**ATCO Gas Australia Proposed
Access Arrangement for the Mid-West and
South-West Gas Distribution Systems**

**Review of Technical Aspects of
the Proposed Access Arrangement**

**Report to
Economic Regulation Authority of
Western Australia**

June 2014

Figure 26: EMCa assessment of growth NPV with B2 and B3 volumes reduced to actual levels during AA3

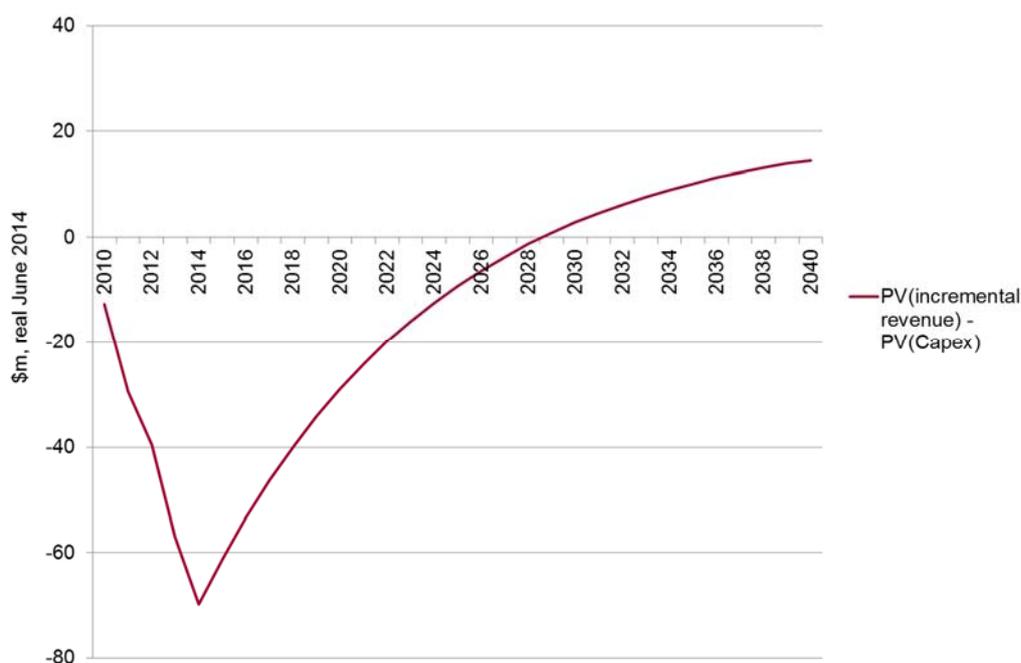
291. We have undertaken a sensitivity test on ATCO's annual volume assumption, and the resulting NPV chart is shown in Figure 26.

Figure 36: ATCO proposed expenditure on replacement of metallic mains

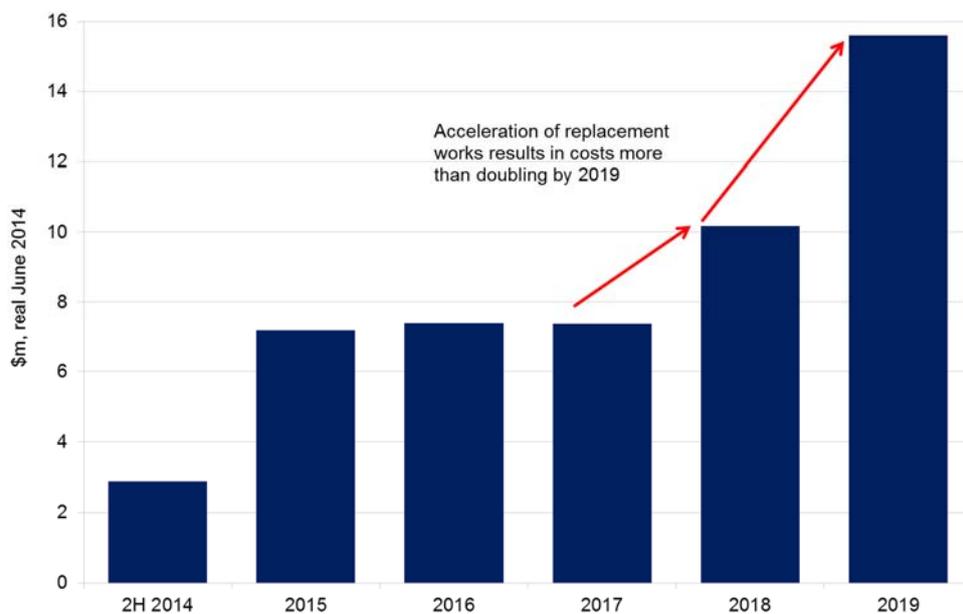
392. In relation to the increased expenditure ATCO has assumed will be incurred in replacing unprotected metallic mains in 2018 and 2019 (see Figure 36), it would appear that ATCO has used the end of the AA4 period as an artificial deadline to complete this work. Apart from the concerns we have about the increased expenditure in the last two years of the AA, we also question whether ATCO will be able to deliver the programme within the shortened period.

Figure 41: New B3 customer annual consumption levels

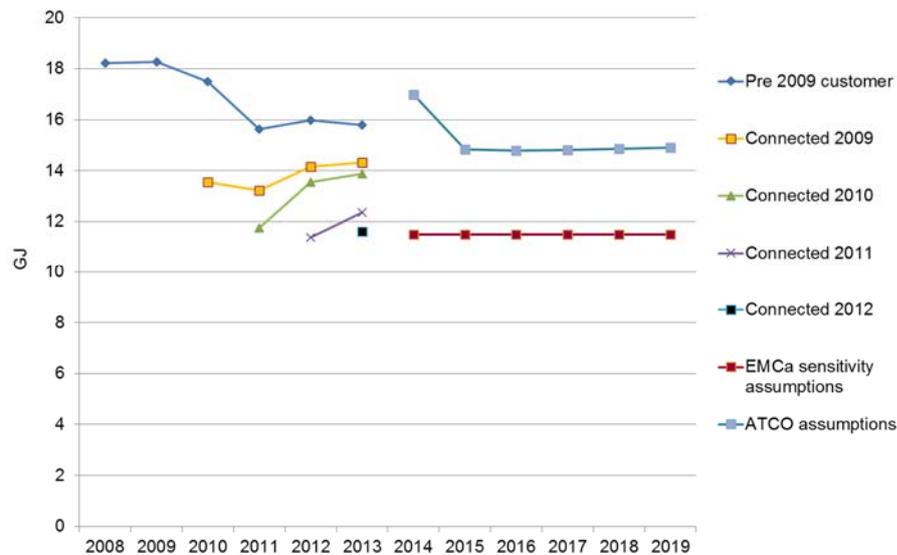
- Better insulated homes, requiring less energy overall.
408. We asked ATCO to provide information on the annual consumption of new customers, as distinct from existing customers. ATCO provided information, which showed a steeply declining level of consumption for each annual tranche of new customers (see Figure 41).

411. Given our concern with this aspect of ATCO's analysis, we have tested the sensitivity of its results to a change in the annual level of consumption for B3 customers of 11.5 GJ (i.e. 3-5 GJ p.a. lower than ATCO has assumed), which is around the level of annual customers connecting in 2011 and 2012, the most recent years for which ATCO provided data, as can be seen from Figure 41.

Figure 43: Effect of assuming no real increase in tariffs

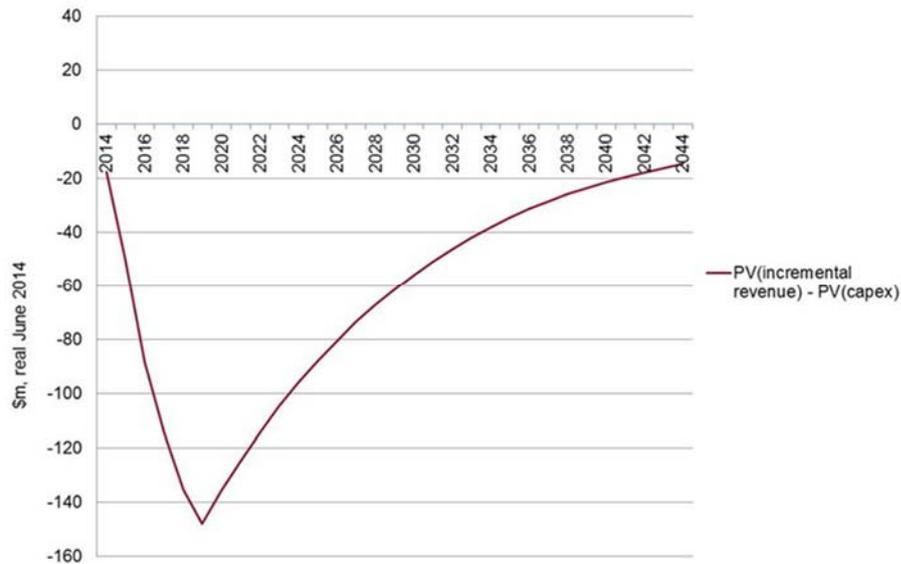
415. We do not consider it valid to assume price rises, which are based on recovery of the higher costs resulting from the proposed high levels of capex, in justifying that capex because there is an inherent element of circularity in this approach. We consider that a more reasonable proposition is to test whether the proposed expenditure can be justified under an assumption that tariffs do not rise in real terms – that is, they keep pace with inflation. When we made this change to ATCO's analysis (in conjunction with the change to new customers' annual consumption as above) we found that the NPV becomes negative (see Figure 43), which means that the aggregated expenditure fails the incremental revenue test.

Figure 58: *Finance & tax expenditure*

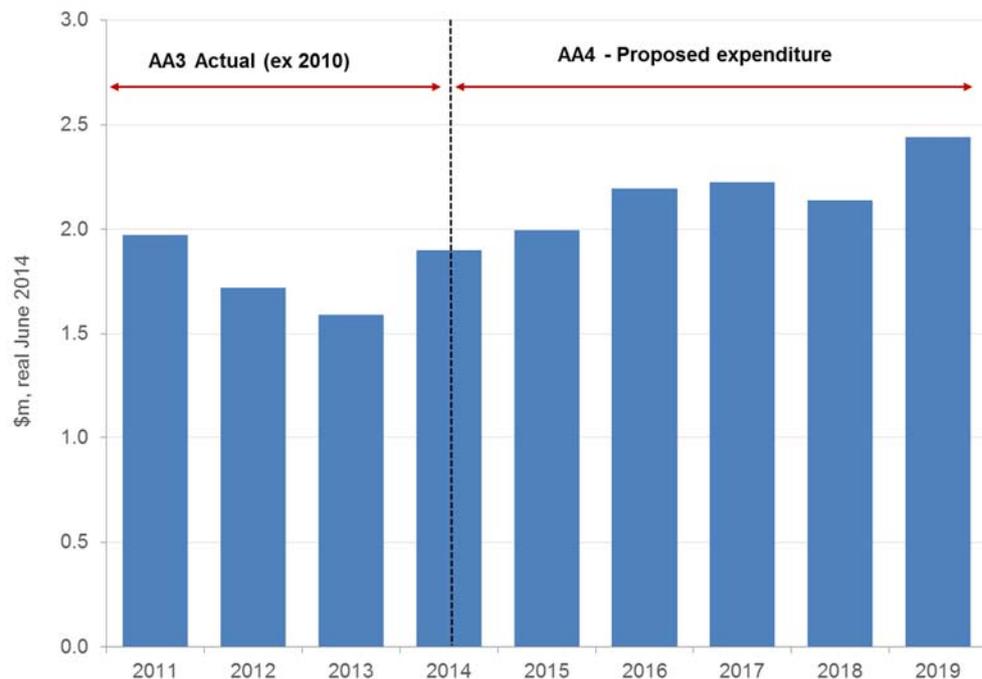
530. The finance and tax opex category includes the costs required to manage the transactional requirements, ongoing legislative, regulatory and standards and are forecast to increase by 24% from 2011 - 2019.
531. Figure 58 compares ATCO's proposed expenditure on this corporate cost category with the costs actually incurred in AA3. As this figure highlights, average annual expenditure over AA4 is \$0.4m above the AA3 average of \$1.8m from a net headcount increase of two. ATCO has not sought to explain the 25% headcount increase since 2011.

Figure 59: HR and corporate affairs opex

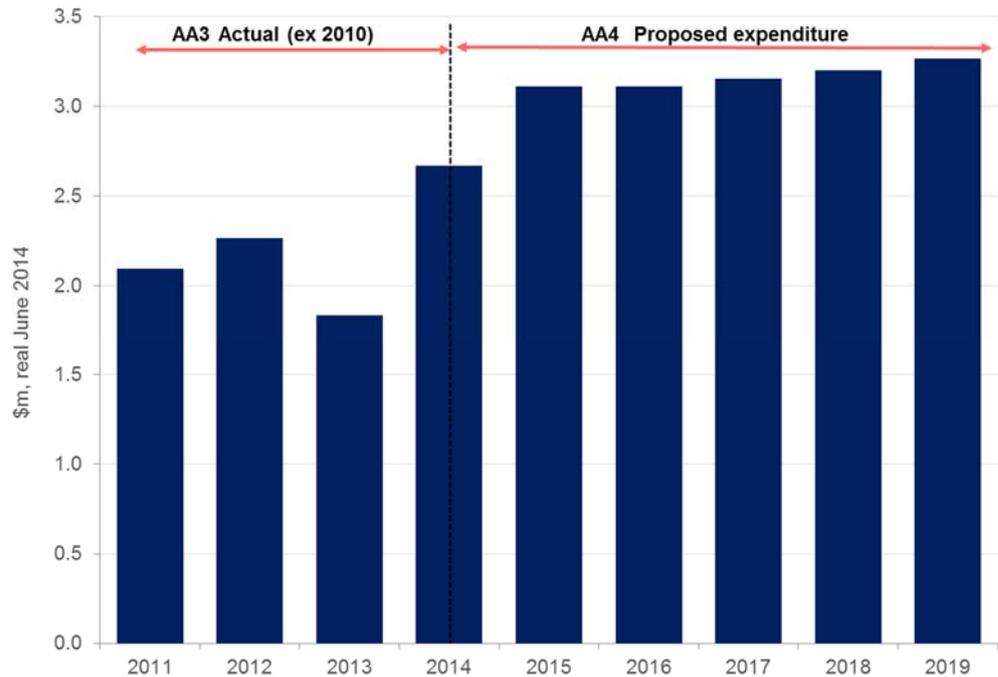
532. Over AA4, ATCO has projected that human resources (HR) and corporate affairs opex will increase by 56%. This has been attributed to growing HR and corporate affairs teams, which ATCO has noted will be at their planned level by 2015, with modest real increases forecast for the balance of AA4 due to real remuneration increase.
533. Figure 59 compares ATCO's proposed expenditure on this category of corporate support costs with the actual expenditure incurred in AA4. As this figure highlights, average annual expenditure over AA4 is expected to be \$1m higher than the AA3 average of \$2.2m. ATCO has offered no specific explanation of the 75% increase in headcount since 2011.

Figure 70: ATCO's assumed UAFG rate

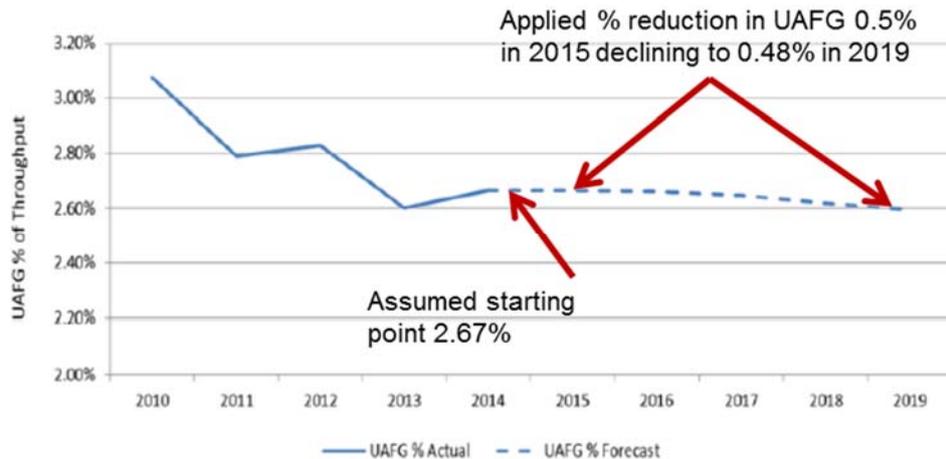
612. As Figure 70 highlights, ATCO has had some success in reducing the rate of UAFG over the last three years, with the rate falling from over 3% to 2.6%. The benchmarking analysis provided by ATCO also indicates that it currently has one of the lowest UAFG rates of its peers.²⁶⁶

- the extent to which ATCO had taken into account the effect of the asset replacement programme on leakage rates in AA4;
- the assumption implied by Figure 52 of ATCO's AAI that UAFG would rise from 2.6% in 2013 to 2.67% in 2014 and take five years to return to its 2013 level; and
- the 2.67% starting point that ATCO adopted when projecting the path that the UAFG rate will take over AA4.

614. We therefore sought further information from ATCO on these issues. Based on the additional information ATCO provided, it would appear that;²⁶⁷
- The 2.6% estimate appearing in Figure 52 of the AAI in 2013 may have been an error, because the monthly data provided by ATCO for the first 11 months of 2013 indicates that the average UAFG rate was 2.76% while the minimum rate over this period was 2.65%.

Figure 71: Actual UAFG rate over AA3 and trend line

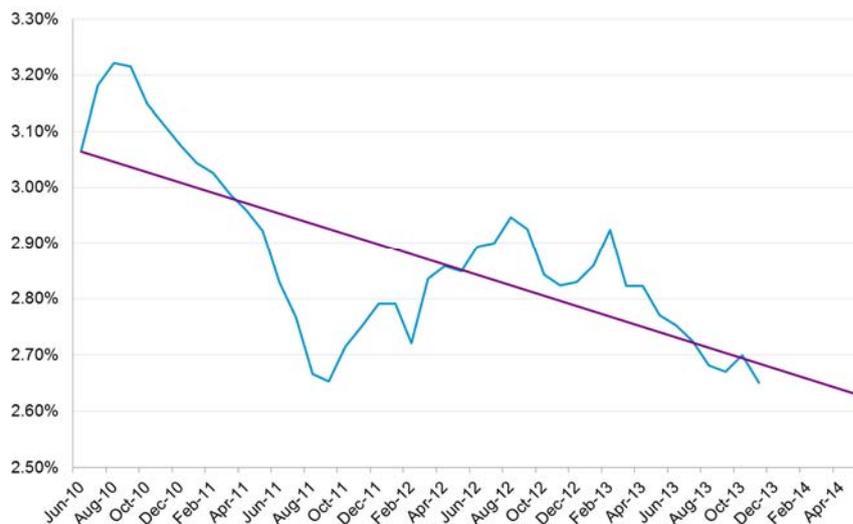
616. In short, we are of the view that the starting point for the AA4 UAFG rate should be set by reference to the trend line observed in AA3, rather than a single observation, because as the data provided by ATCO demonstrates (see Figure 71), the UAFG rate can exhibit some volatility throughout the year and over time.

Figure 75: Comparison of ATCO AA3 actual labour cost increases & labour indices (%)²⁸⁴

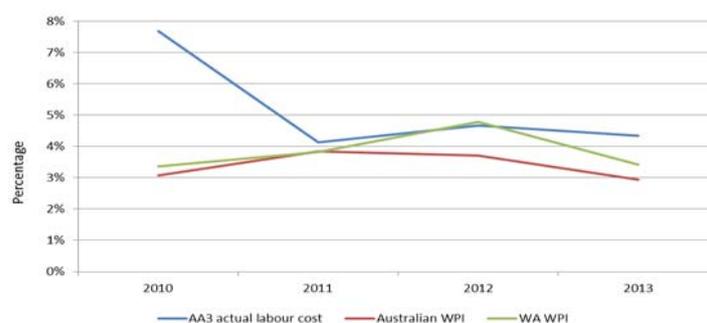
655. ATCO provided a comparison of its labour costs and the WA WPI and Australian WPI as shown in Figure 75. ATCO argues that actual labour costs will again be materially higher than the WPI in establishing its next labour contract. It therefore proposes an adjustment above the WA WPI.
